Addendum No. 2

May 1, 2024

City Project No.: 23-033
Roads Program Capital Improvement Project

DRAWING NO.
09
SHEET:
09 OF 49

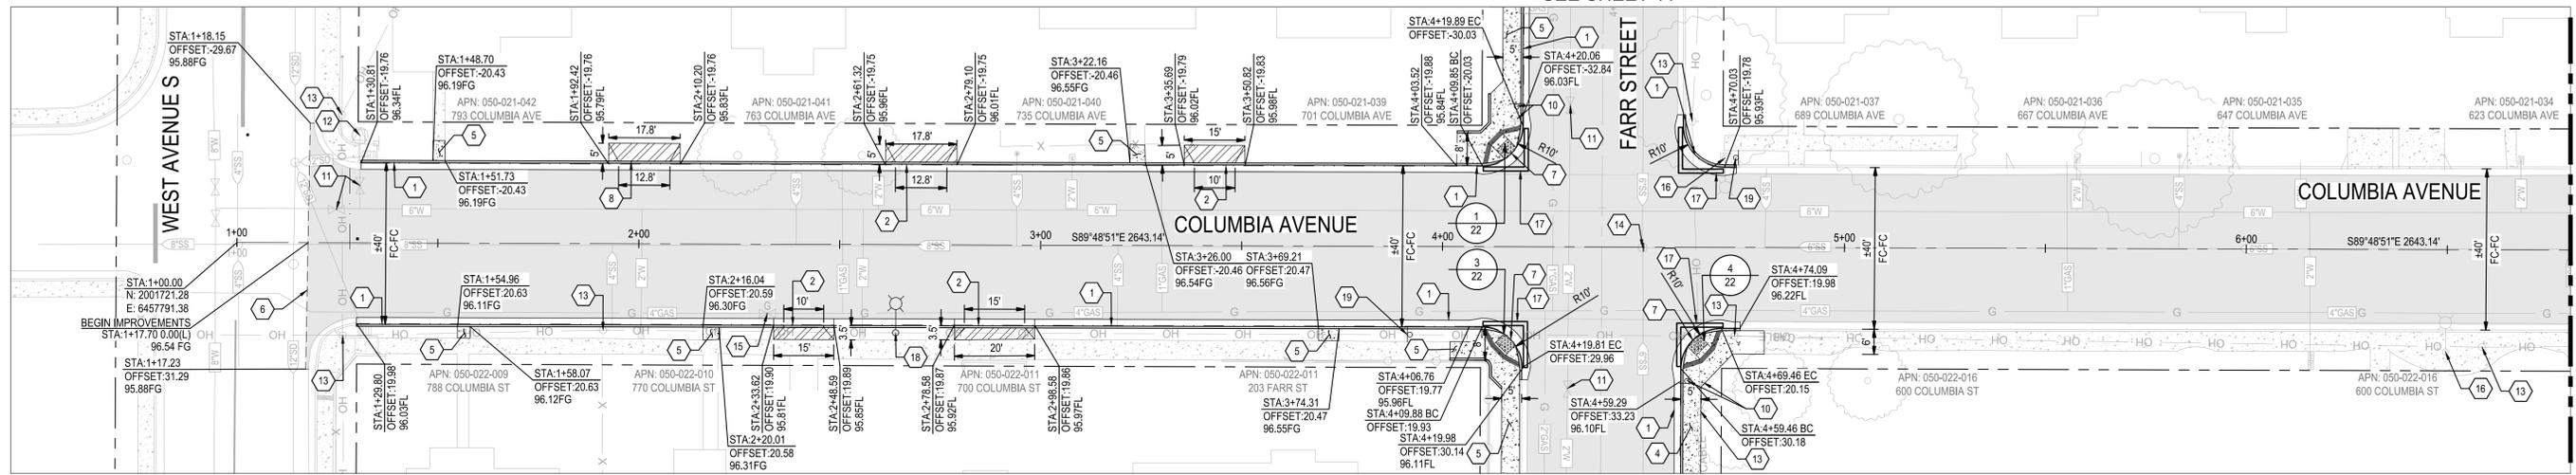
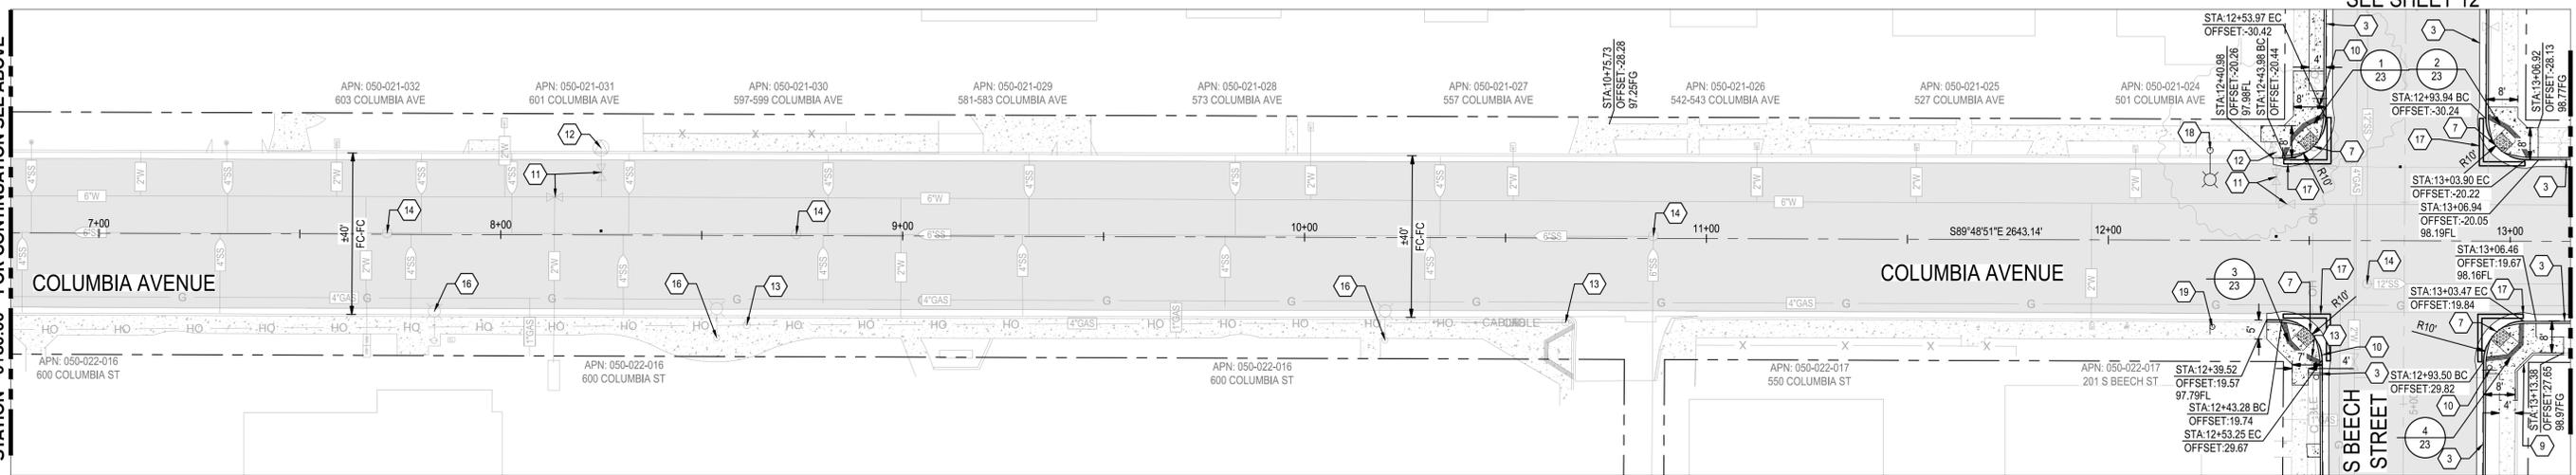
Q1: Plan sheet 09 of 49 note 13 calls for ½” Type A PG 70-10 HMA to be used for asphalt improvements. However, the project specifications call out a base of ¾” and a surface layer of ½” aggregate gradation with a binder of PG 64-10. Please clarify what HMA material will be required.

A1: Plan Sheet 09 of 49, note #13 has been revised. ***The base layer shall consist of a ¾” aggregate gradation and the surface layer shall be ½” and the HMA type shall be type A. The binder shall be PG 64-10.*** Please see attached revised sheet 09.
